Service Information No. 53
Kundendienst-Mitteilung No.
Service Information No.
Información de servicio No.
Servicemeddelelse No.

Date / Datum / Date / Fecha / Dato October 1973

From serial no. 102070 and onward the transmitter T122 will be produced with a somewhat modified aerial output in order to eliminate the risk of flash over.

Old type

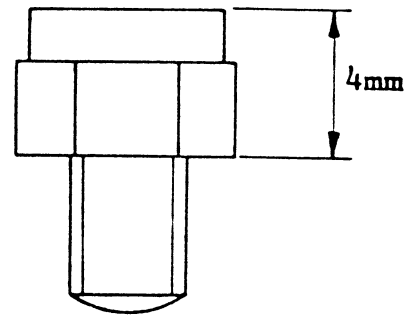
A) Larger distance between contacts in the drum change-over switch and consequently introduction of a new type of contact screws (the small yellow plastic screws that are delivered along with each transmitter).

is only to be used in transmitters with a serial no. lower than 102070.

is only to be used in transmitters with a serial no. from 102070 and onwards.
